CITY OF DAYTON

ADDENDUM NO. 2

GOLF COURSE MAINTENANCE BUILDING

FOR THE DEPARTMENT OF RECREATION

7 SECTION DETAIL - FIBER CEMENT PANEL HEAD

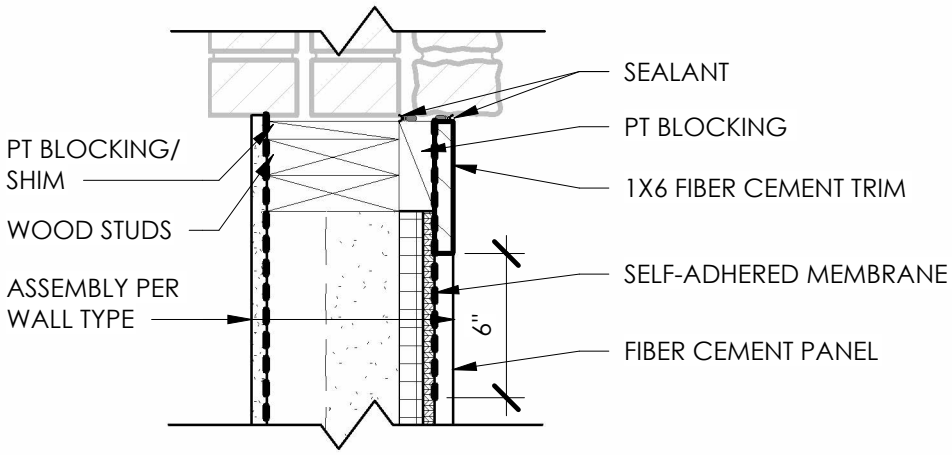
2. **REVISED DRAWINGS** – see attached revised drawings. The changes are as follows:
   A. Sheet A-S-001 – GENERAL NOTES
      i. MODIFY delegated design notes.
   B. Sheet A-S-100 – DESIGN CRITERIA & SECTIONS & DETAILS
      i. MODIFY lintel schedule for mechanical openings as needed.
   C. Sheet SK-01, SK-02, SK-03 – FIBER CEMENT PANEL DETAILS
      i. REPLACE details 7, 4, and 1/A-A-301 with revised details 7/SK-01, 4/SK-02, and 1/SK-03 attached.
